SensorLab Status Word Endianness Inconsistency

PLC Data – SLS Output Register via EIP Generic Module Connection (configured Low-byte first)

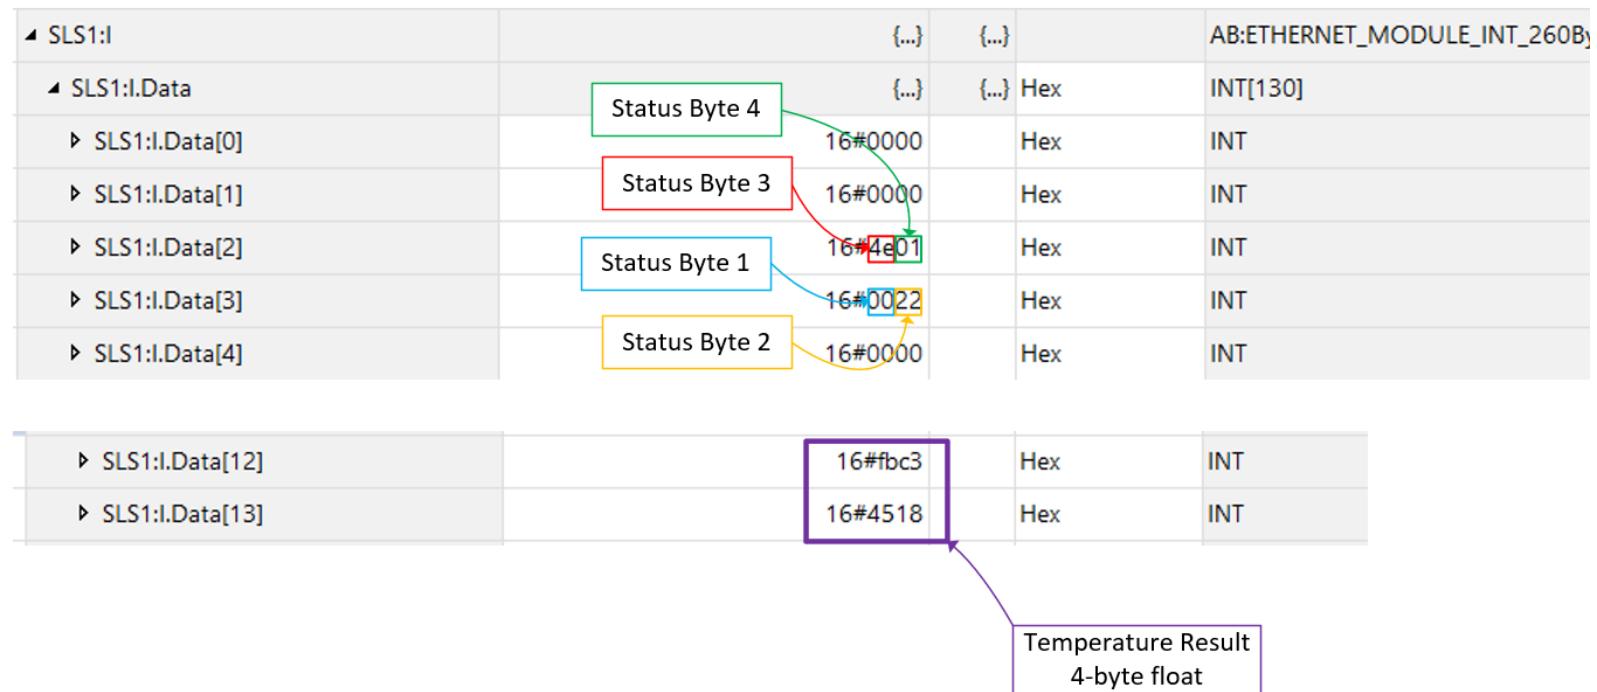
- The result fields (e.g., Temperature 4-byte float, etc) decode correctly in the PLC and the raw words show little-endian byte order.
- However, the status word/bytes **still arrive high-byte-first**, i.e., their byte order doesn't follow the low-byte-first setting.

PLC Data - SLS Custom Telegram via serial → EIP (Anybus ABC3007-A)

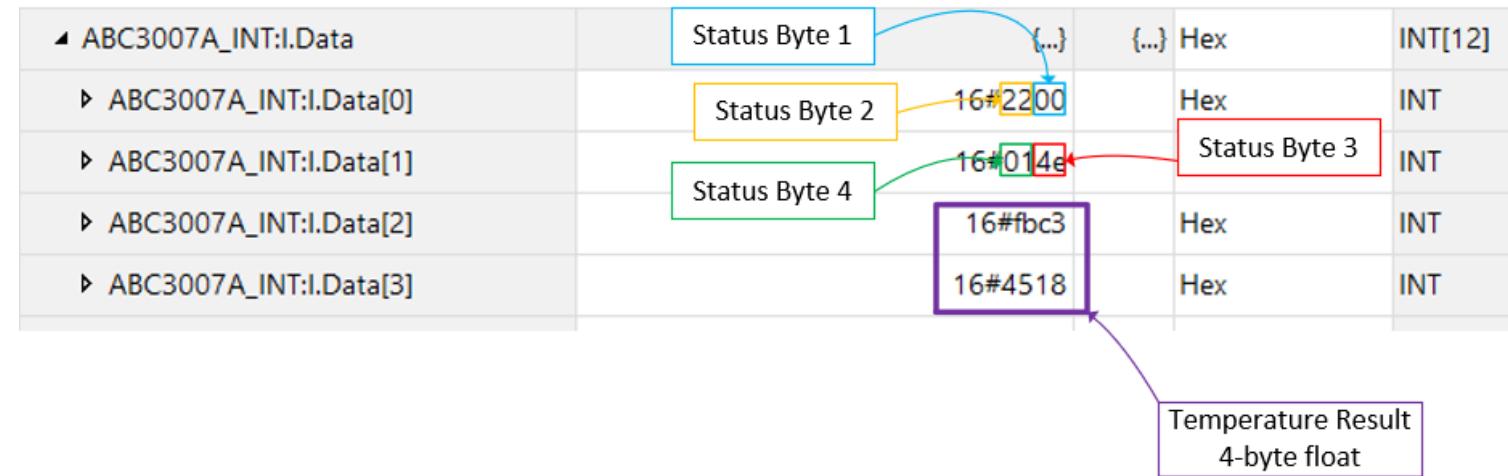
- Both the result fields (e.g., Temperature 4-byte floats, etc) and the status bytes decode correctly in the PLC as low-byte-first; the raw words show little-endian order.
- Note: the telegram editor **does not offer a big-endian option for status words**—only result fields allow endianness selection.
